# Presentation

## To the Riel Community Committee on the Waverley West Southwest Neighbourhood Secondary Plan

Monday April 8, 2013

Figure 3.20: Mid Block Trail Crossing, Unsignalized - Combined Multi-Use Trail

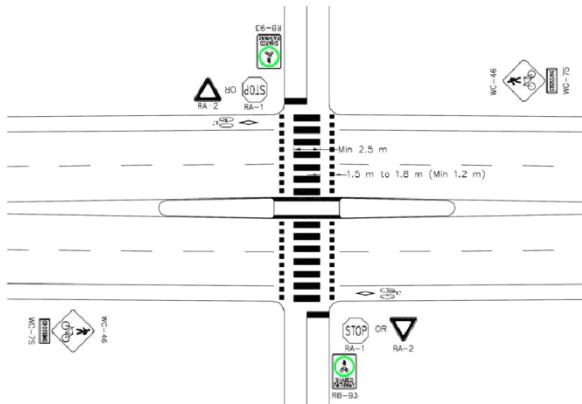
As per the TAC guidelines, we would like to see the pedestrian and bicycle crossings along the greenway system utilize elephant feet markings to alleviate the need for cyclists to stop and dismount at crosswalks. The elephant feet markings provide a separate space outside the crosswalk for a cyclist that allows them to cross a roadway without being legally required to dismount their bicycle.
